**Re: Plan Commission PC #22-018
Responses to Round 2 Comments**

Olive-Mary Stitt Elementary School
303 E. Olive Street
Arlington Heights, IL 60004

STR Project #22050

EXHIBIT A

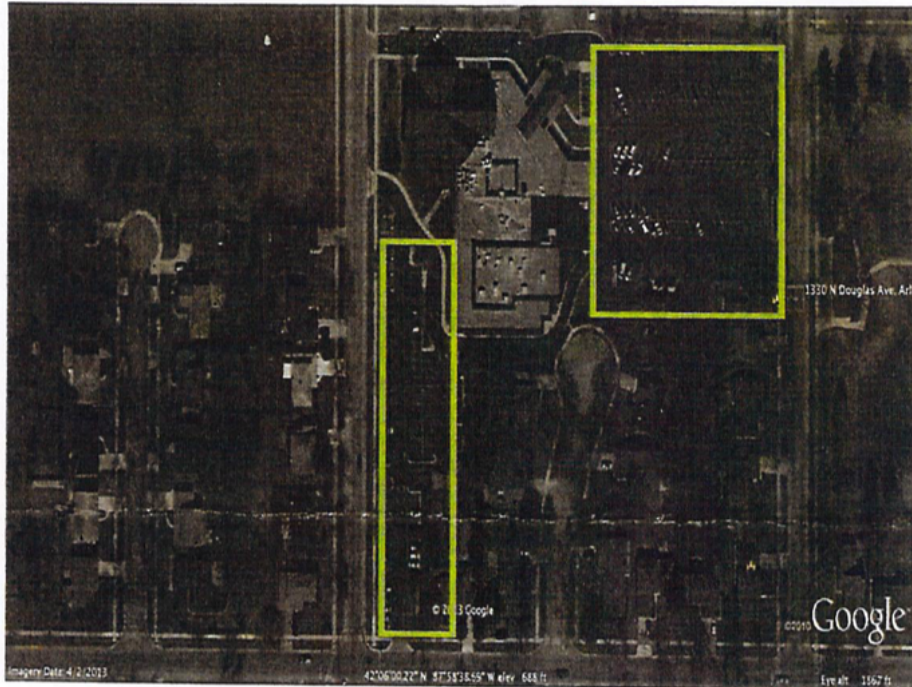
42. No response was provided to comment #30. Please provide a response.

RESPONSE: Response to "Provide details on the length of the parking agreement with the Orchard Church. Are there options for renewal? Is usage restricted to certain times or number of spaces? Due to the capacity constraints within the Olive parking lot observed during PM pick-up, please consider requiring certain staff to park within the Orchard Church lot." is as follows:

- Term: 10 years 11/15/22 - 11/15/2032
 - Automatic 5-year renewal
- School Access to Church Parking Lots Highlighted in Exhibit A
 - Hours 7:00am - 10:00pm
 - It can be used for the overflow parking for students, teachers, parents, legal guardians, other invitees of students, and other members of the public dropping off and picking up students for school and attending school-related events, including school faculty and staff meetings, parent-teacher meetings, extracurricular school activities, educational programming events and school athletic events featuring the School District's athletic teams.
